ENGINE - FUEL AND CONTROL - FUEL AND CONTROL - REPLACEMENT OF FUEL FEED TUBE -  
CATEGORY CODE 4 - MOD.ENG-73-0018

V2500-ENG-73-0018

Replacement of fuel feed tube  
Fig.1

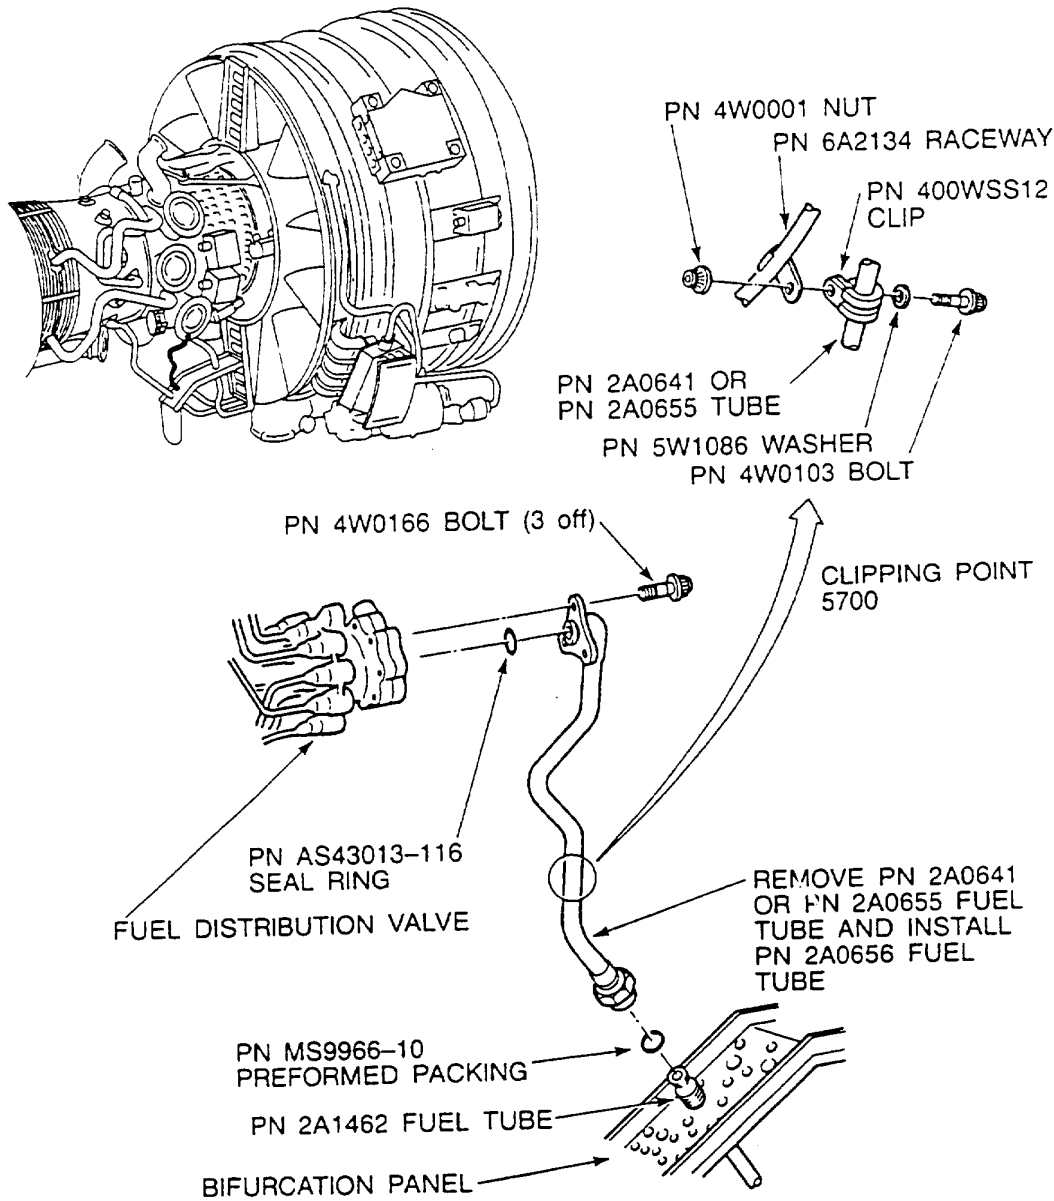
Mismatching may occur at both ends of the fuel feed tube connecting the bifurcation panel to fuel distribution valve.

Difficulty of tube connection was reported. Investigation clarified that the fuel tube is slightly short.

(a) 2A0656 Tube supersedes 2A0655 and/or 2A0641 Tube.

- (1) Remove 400WSS12 Clip from 2A0641 and/or 2A0655 Tube.
  - (a) Remove 4W0001 Nut, 5W1086 Washer and 4W0103 Bolt to release the clip.
  - (b) Remove the clip from the tube.
- (2) Remove 2A0641 and/or 2A0655 Tube.

- (a) Disconnect 2A0641 and/or 2A0655 Tube from 2A1462 Tube at the bifurcation panel.
  - (b) Remove three 4W0166 Bolts which attach 2A0641 and/or 2A0655 Tube to the fuel distribution valve and remove the tube.
  - (c) Remove AS43013-116 Seal ring from 2A0641 and/or 2A0655 Tube and MS9966-10 Seal ring from 2A1462 Tube. Discard removed seal rings.
- (3) Install 2A0656 Tube.
    - (a) Lightly lubricate a new MS9966-10 Seal ring with CoMat 10-038 petroleum jelly or CoMat 10-060 liquid paraffin. Install the seal ring on 2A1462 Tube at the bifurcation panel.

- (b) Lightly lubricate a new AS43013-116 Seal ring with CoMat 10-038 petroleum jelly or CoMat 10-060 liquid paraffin. Install the seal ring on 2A0656 Tube.
- (c) Attach 2A0656 Tube to the fuel distribution valve with three 4W0166 Bolts.
- (d) Connect 2A0656 Tube to the 2A0641 Tube at the bifurcation panel.
- (e) Torque the bolts to 85 to 105 lbfin (10 to 12 Nm). Torque the tube connector to 1150 to 1250 lbfin (130 to 141 Nm). Safety with CoMat 02-126 lockwire.
- (4) Clip 2A0656 Tube to 6A2134 Raceway.
  - (a) Install 400WSS12 Clip to 2A0656 Tube.
  - (b) Install the clip to the lug of 6A2134 Raceway using 4W0103 Bolt, 5W1086 Washer and 4W0001 Nut.
  - (c) Torque the nut to 36 to 45 lbfin (4 to 5 Nm).
